Subject: Dec. 8th Beacon Presentation

Re: North Square at the Mill District and Lack of Family-Friendly Features

Re: Application for Comprehensive Permit – 134 Montague Road (“North Square”)

*Figure 1a – Google Earth historical imagery, 2011. Figure 1b – Google Earth current imagery, 2014*

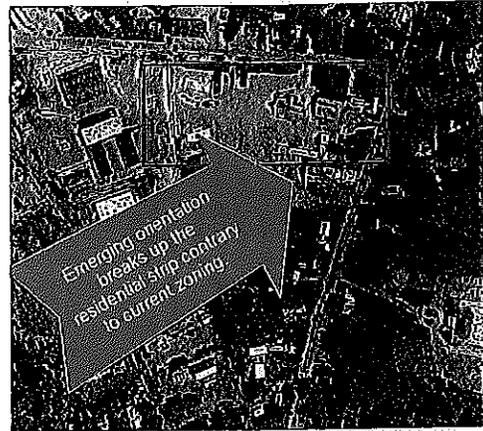
First, the area around the corner of Montague Road and Cows Road is being changed from a residential strip interrupted by a small road leading to a commercial location, to what seems to be a defacto single non-residential commercial property that interrupts the residential character of Montague Rd. Figure 1a and 1b show areal photographs from 2011 and 2014 side-by-side. The different orientations of the rectangles are an attempt to show how the new commercial property is increasingly a single commercial property, without maintaining the residential quality of Montague Road. This change converts our property from one in the middle of a residential area to one at the edges of a large, open, and clearly commercial zone, with the loss of peace and privacy that comes with it.

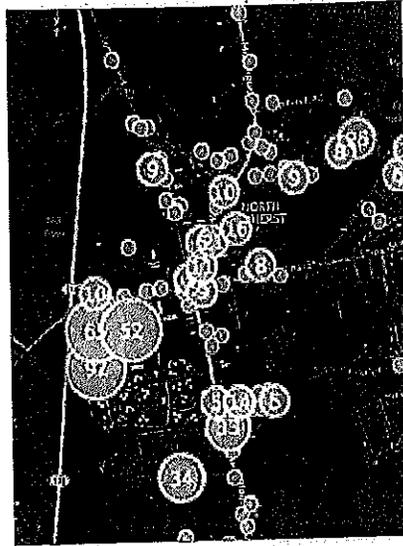
Third, the high density residential property proposed under the 40B bypass of zoning restrictions may degrade the quality of life in our neighborhood, still generally quiet in the evening, although now a weekend hotspot with the new stores. Does the town of Amherst and its residents need yet another noisy apartment complex featuring, inevitably, high densities of student occupancy? The map shown in figure 2 shows the locations of noise complaints according to town GIS data. Apartment complexes like the Townhouses and Puffton Village feature many tens of noise complaints, while the area around Cowls Road only shows a few individual complaints. We are concerned that the new development will lead to similarly high levels of evening and weekend noise, an externalized cost of development to be absorbed by the town at no apparent expense to the non-resident commercial interests that do not have to bear such costs to their personal quality of life.
